UNITED STATES PATENT AND TRADEMARK OFFICE

APPLICATION NO.	FILING DATE	FIRST NAMED INVENTOR	ATTORNEY DOCKET NO.	CONFIRMATION NO.
10/798,120	03/11/2004	Lawrence M. Janesky	257-011631-US(PAR)	8802
2512	7590	04/09/2008		
PERMAN & GREEN 425 POST ROAD FAIRFIELD, CT 06824			EXAMINER GILBERT, WILLIAM V	
			ART UNIT 3635	PAPER NUMBER
			MAIL DATE 04/09/2008	DELIVERY MODE PAPER

Office Action Summary	Application No. 10/798,120	Applicant(s) JANESKY, LAWRENCE M.	
	Examiner William V. Gilbert	Art Unit 3635

DETAILED ACTION

Figure 2 from Jaenson

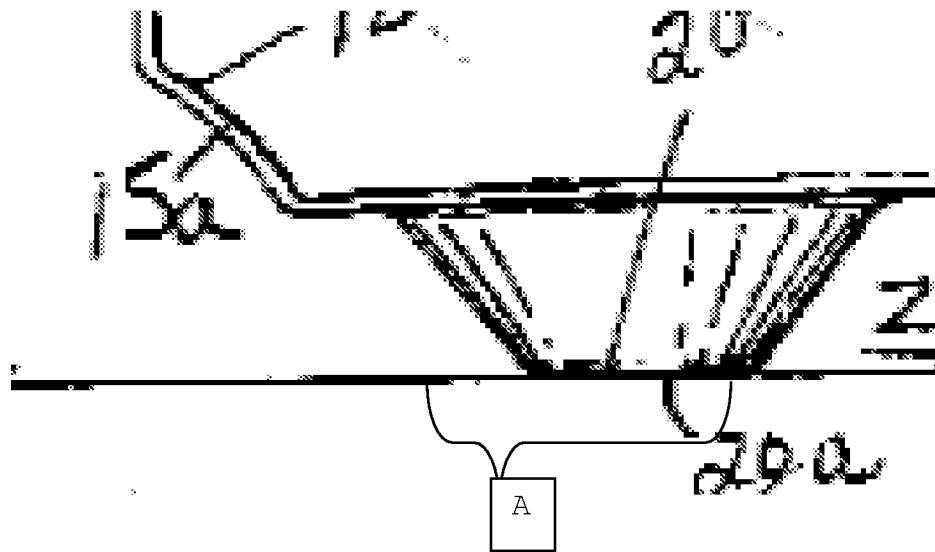
Claim 1: Janesky discloses a drain panel assembly having a plastic drain panel (Fig. 2: generally: Abstract, line 5) having an upper panel section (13) extending vertically up from a lower skirt section (15), the upper section is adjacent a basement wall (11) and spaced by spacers (18), the lower skirt has a substantially continuous wall portion extending outwardly from the upper panel section away from the wall and is in substantially continuous contact with the footing section (via 20a as shown in applicant's drawings and specification; see "A" from attached Figure 2 from Jaenson below) so that an outer surface of the skirt faces away from the upper panel section to

form a longitudinal water conduit (15a, 23) extending along the length of the footing, the conduit being provided with a plurality of spaced drain openings (23) for draining water over the footing surface. While the Janesky reference discloses the wall portion extends continuously along a length of the footing, it does not disclose that extends along an entire length of the footing. It would have been obvious at the time the invention was made to a person having ordinary skill in the art as a matter of design choice to have the as claimed because applicant failed to state a criticality for the necessity of the limitation and the prior art of record is capable of being designed to meet the limitation as claimed. See MPEP 2144.04(IV)(A) citing *Gardner v. TEC Systems, Inc.*, 725 F.2d 1338 (Fed. Cir. 1984), the Federal Circuit held that, where the only difference between the prior art and the claims was a recitation of relative dimensions of the claimed device and a device having the claimed relative dimensions would not perform differently than the prior art device, the claimed device was not patentably distinct from the prior art device. Applicant should note that only the panel assembly is claimed. The phrases "adapted to control...supporting footing", lines 1-4, and "for draining...drain tile" lines 21, 22 are statements of intended use of the claimed invention and must result in a
